SG ARCHITECTURE, LLC

DESIGN REVIEW APPLICATION | SUPPLEMENTAL INFORMATION

SGA PROJECT NO. 20-119

Design Review Application DR-23-01
Supplemental Information Submittal in
Response to Incomplete Notice

1 GROUND FLOOR PLAN + WILLAMETTE FALLS DRIVE ELEVATION

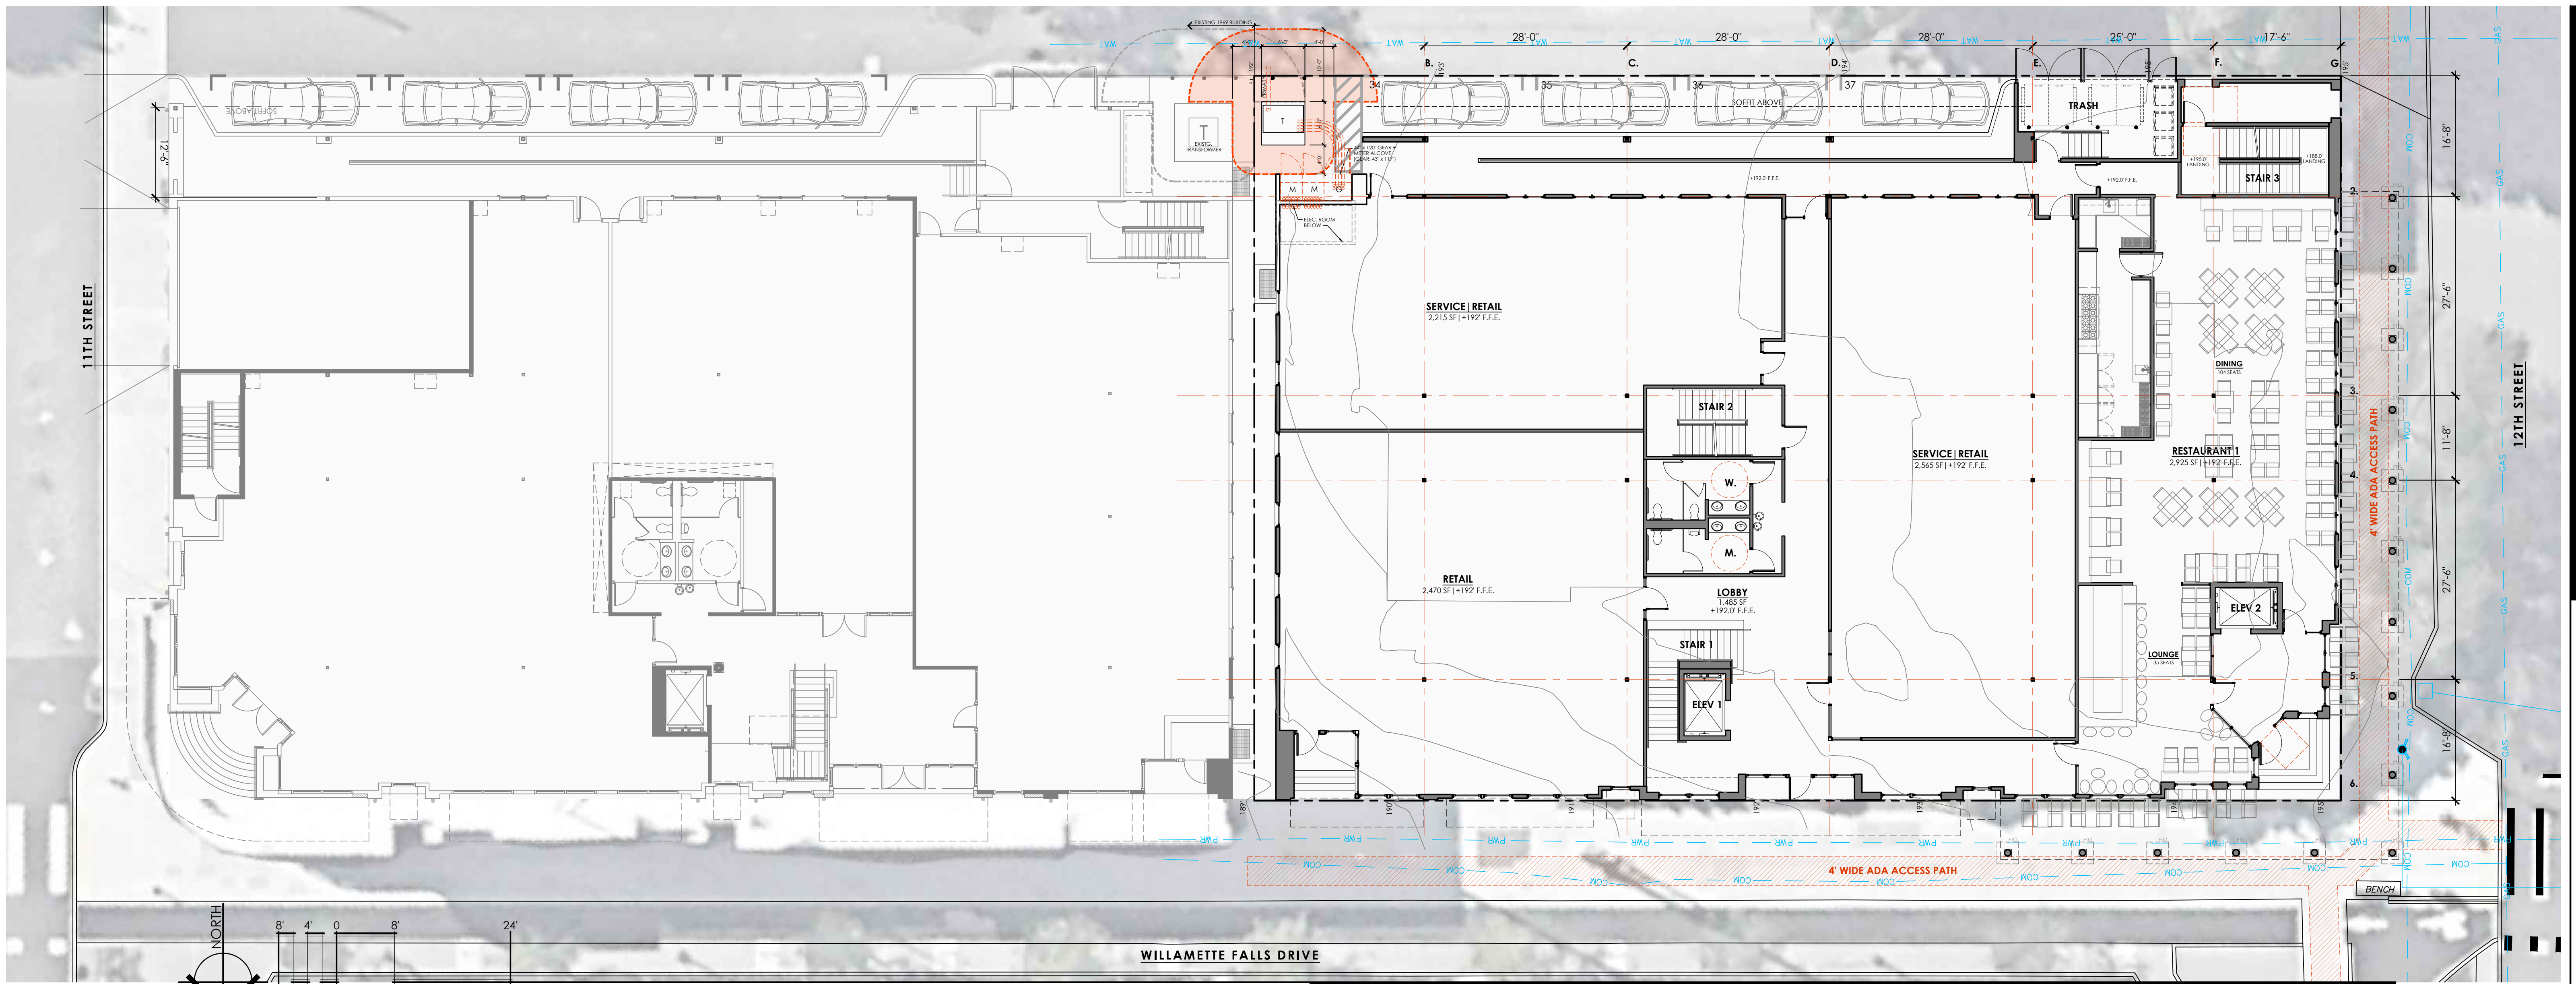
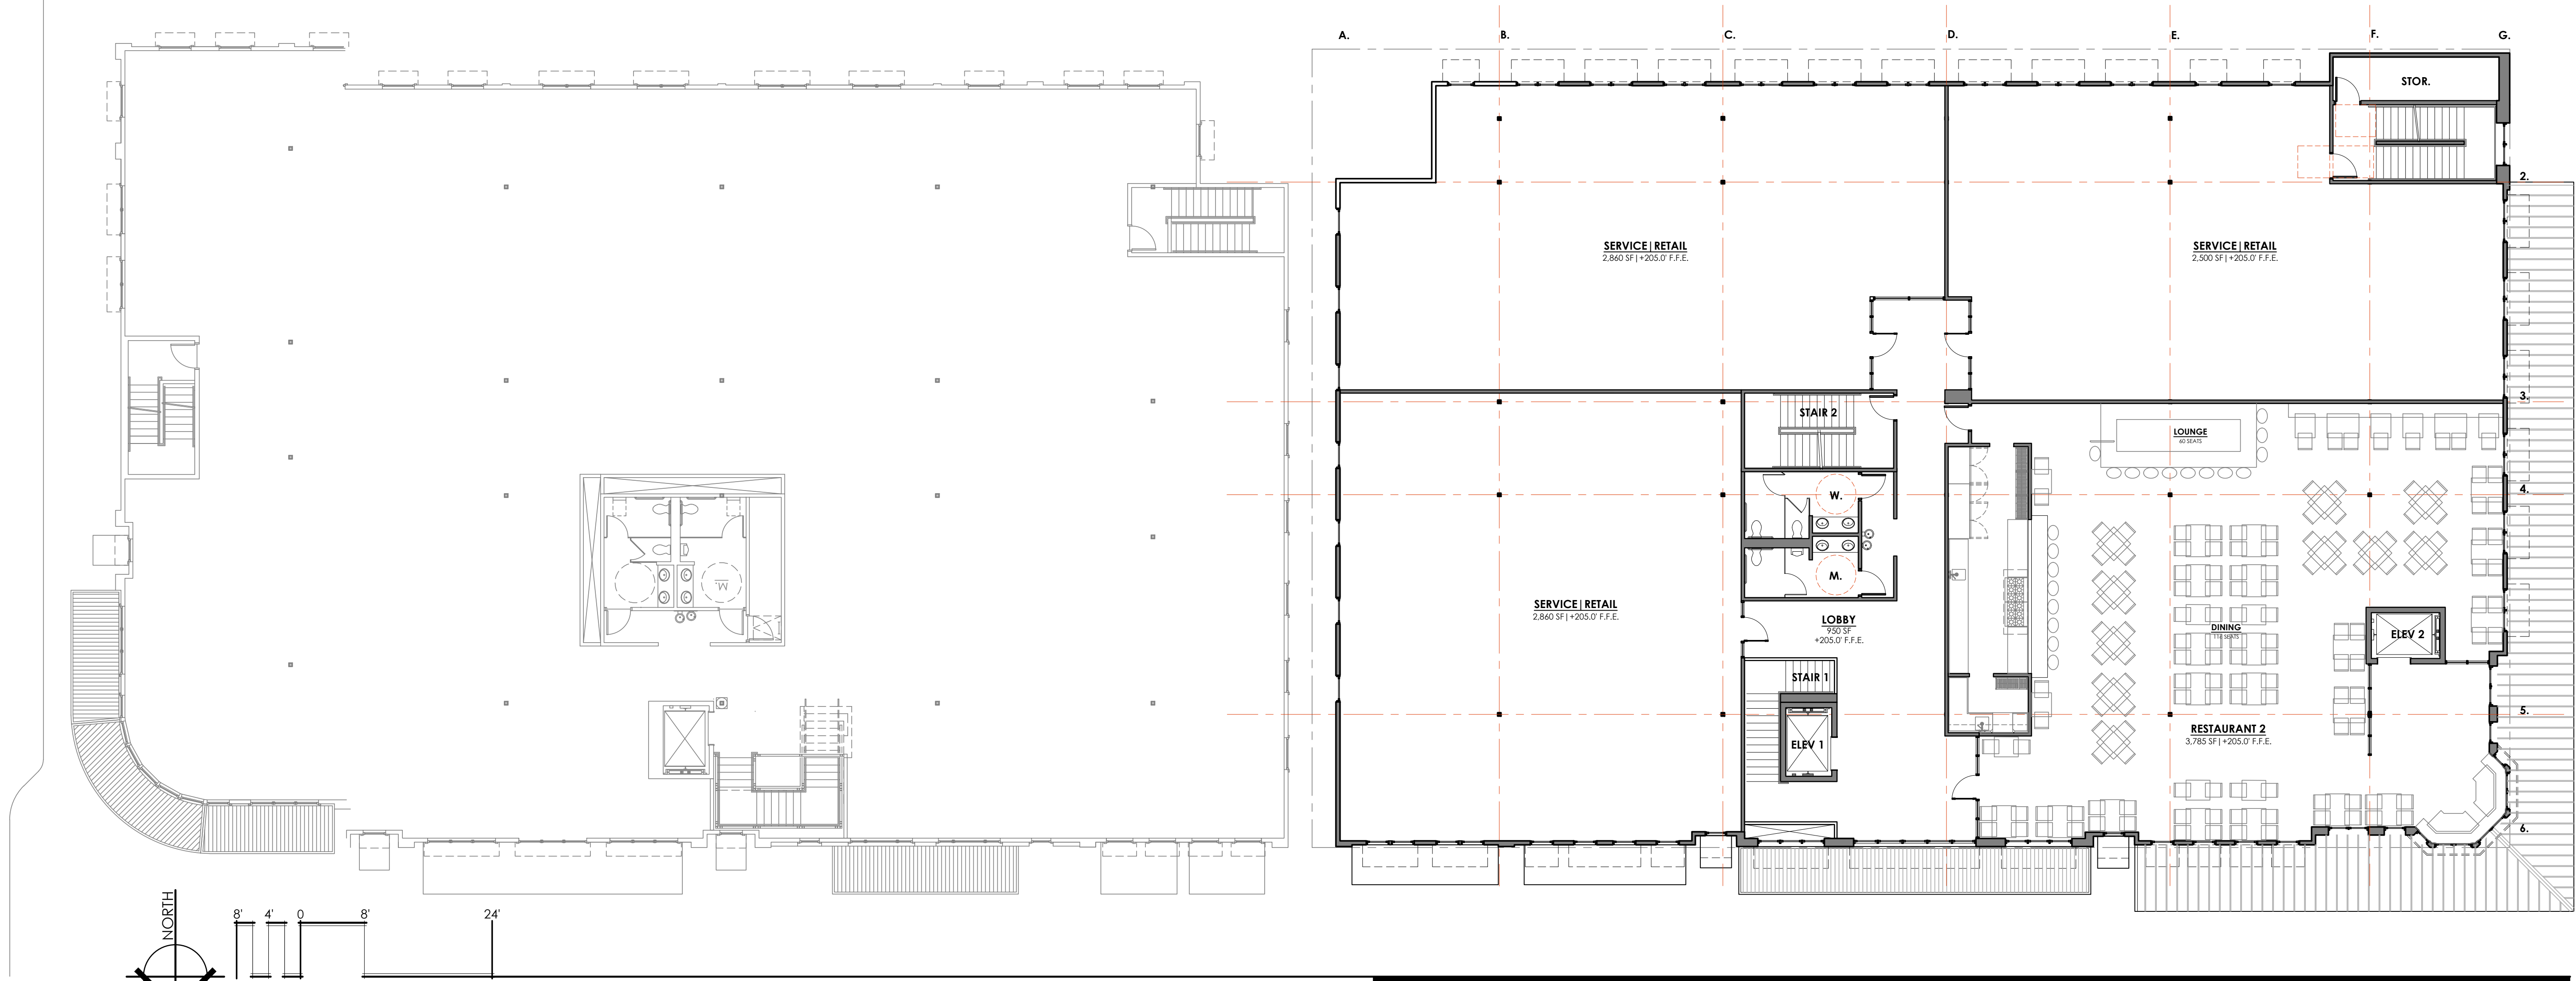
2. *Building Height. Please call out proposed building heights on all elevations per methodology in CDC 41.005 and 41.030. As a non-habitable projection, Western False Fronts are exempt from the height limit.*

These footings have been shown on the Ground Floor Plan (see "1949 MIXED USE.1949 WILLAMETTE FALLS DRIVE.03_WFD ELEVATION (0420)"), along with the current site utilities. As shown, there should be little chance of conflict. In addition, the bottom of the footings are proposed at approximately 20" below grade, which should place them well above any utility lines nearby.

- c. Please provide a proposed outdoor seating layout along both Willamette Falls Drive and 12th Street, including clear demarcation of the ADA path.

The drawing "1949 MIXED USE.1949 WILLAMETTE FALLS DRIVE.03_WFD ELEVATION (0420)" has been updated to include illustration of the building's compliance with the 35' height limit standard at a point 5' out from the front of the building/property line per Section 41.005.

The Exhibit "1949 MIXED USE.1949 WILLAMETTE FALLS DRIVE.03_WFD ELEVATION (0420)" exhibit has been updated to show a possible outdoor seating layout. Any outdoor seating would be required to conform to the CDC Section 7.950 "Sidewalk Café Program".

DECORATIVE COLUMN DETAIL
1" = 1'-0"

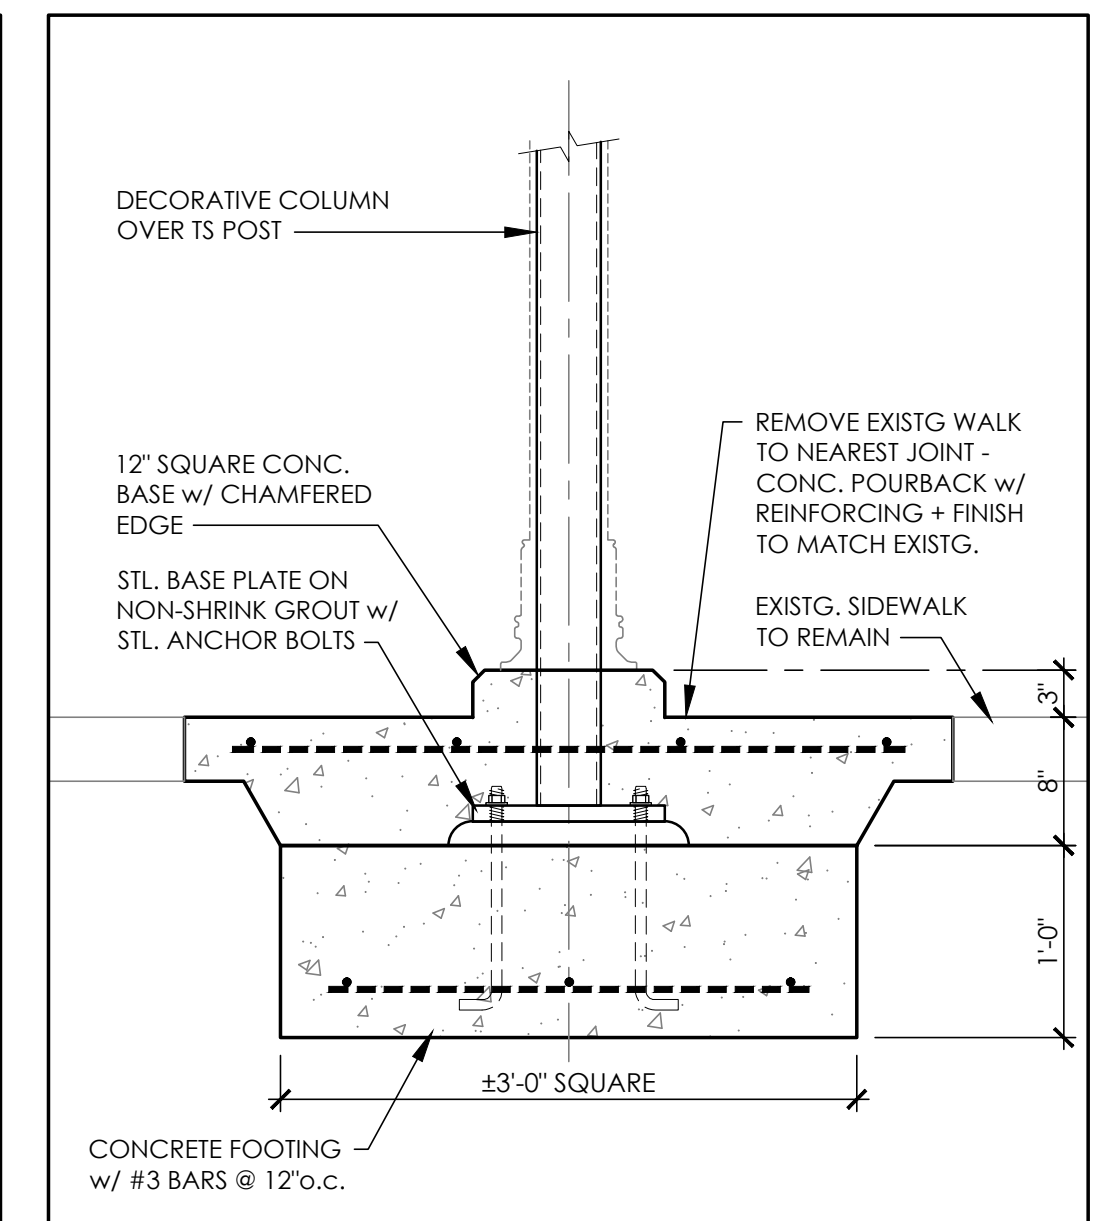
- b. Due to concerns about potential utility conflicts with the pillars proposed along Willamette Falls Drive, please provide a detail in the plans showing how the posts will be anchored to the sidewalk. Will the posts be embedded in the sidewalk or just anchored/bolted down at the surface of the sidewalk? There may need to be 2 different anchoring details – one for wherever the posts are anchored to concrete and one for where the posts are anchored in landscaped area (i.e. along 12th St.).

The Exhibit "1949 MIXED USE.1949 WILLAMETTE FALLS DRIVE.04_12TH STREET ELEVATION (0420)" has been updated to include a footing detail for the canopy posts. The design proposes that the existing sidewalk be removed to the nearest joints, an approximately 3' x 3' x 12'd. footing be poured, and the sidewalk poured back to match the adjacent.
